Part Number Change Notification

Subject: Part Number Change Notification for TDK's C0510 Series Capacitors

Paper Tape (Type 1)

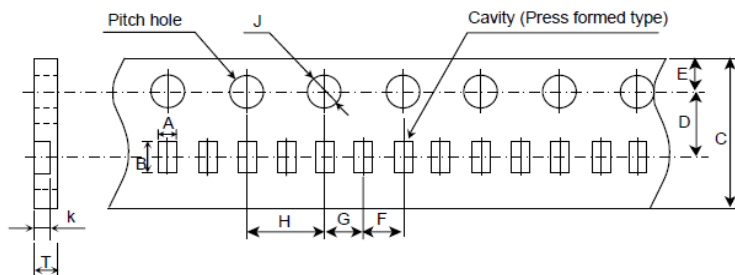
Thank you for your business and continued interest in TDK's ceramic capacitors. This letter is to inform you there has been a part number revision to the C0510 (0204) ceramic capacitor series. Previously, The C0510 Series capacitors were incorrectly released with a packaging character to indicate a 4mm Pitch. While this is typical for the Reversed Geometry Series, the pitch for the C0510 (0204) Series is actually 2mm. There has been no change to the product itself. Items have actually shipped with the correct pitch despite having an incorrect part number. Therefore, we ask that you reference the revised ordering code immediately. TDK is committed to working closely with you to minimize any impact this change may have.

C	0510	X5R	OJ	105	M	30	B	C
Series Name	Case Size	Temperature Characteristics	Voltage Code	Cap Code	Cap Tolerance	Thickness	Packaging Code	Special Code
C	0510 (0204)	X5R (±15%) X6S (±22%) X7S (±22%)	0E = 2.5V 0G = 4V 0J = 6.3V 1A = 10V 1C = 16V	104 (0.10uF) to 105 (1uF)	M (±20%)	030 = 0.30mm	B = 7" Reel, 2mm Pitch	C = Internal
